Docket Number:	21-BSTD-01
Project Title:	2022 Energy Code Update Rulemaking
TN #:	238693
Document Title:	ConSol Comments on insulation requirements for ducts in conditioned space
Description:	N/A
Filer:	System
Organization:	ConSol
Submitter Role:	Public
Submission Date:	7/5/2021 10:39:34 PM
Docketed Date:	7/5/2021

Comments on insulation requirements for ducts in conditioned space

Re: Docket 21-BSTD-01 2022 Energy Code Update Rulemaking

Figure 30: Seven-day moving average indoor (room) and outdoor dew point temperatures for CZ 9 Burbank for summer. Air conditioner operation (on or off) is shown on the secondary axis.

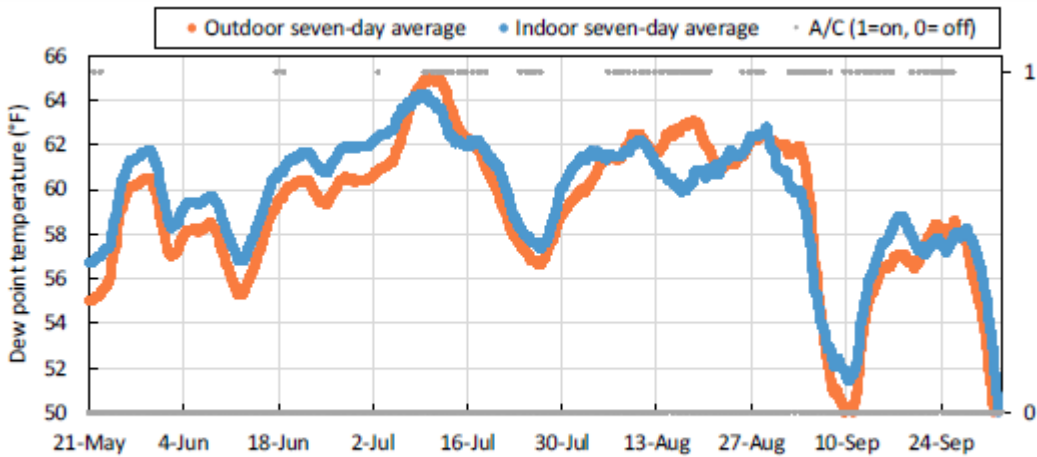
period. The average outdoor temperature was 88F. This test showed that the ambient temperature remained below the supply plenum temperature throughout the test period, meaning that there was no risk of condensation. A study of homes in New Orleans, LA, carried out for NREL by the Building Science Corporation³ compared the performance of homes with and without supplemental dehumidification over the course of approximately 13 months. For homes without supplemental dehumidification, the dewpoint rose above 60F for less than 10% of the time, and above 65F for approximately 1% of the time. While this study did not include data on condensation on ducts, it is worth noting that the time spent at elevated dewpoints is considerably lower than in the models used in the WCEC study – Figure 30 from that study (reproduced below) shows the indoor dew point temperature during the cooling period spending close to 50% of the time above 60F. This figure is from the climate zone which showed the highest likelihood of condensation. The difference between modeled and actual data on dewpoint temperatures suggests that the modeling may underestimate the dehumidification caused by air-conditioning. The possible reasons for any such discrepancy are outside the scope of this comment.

When considering the data from Rheia’s tests, the studies noted here, submissions to the docket from builders experienced in the use of uninsulated ducts (TN#s 238321, 238267, 238263, 238261, 238258, 238239, and 238212), and ConSol’s previous comments submitted to this docket (TN#s 238140 and 238388), it remains ConSol’s position that the requirement for insulation on ducts in conditioned space is unnecessary and should not be included in the 2022 code.
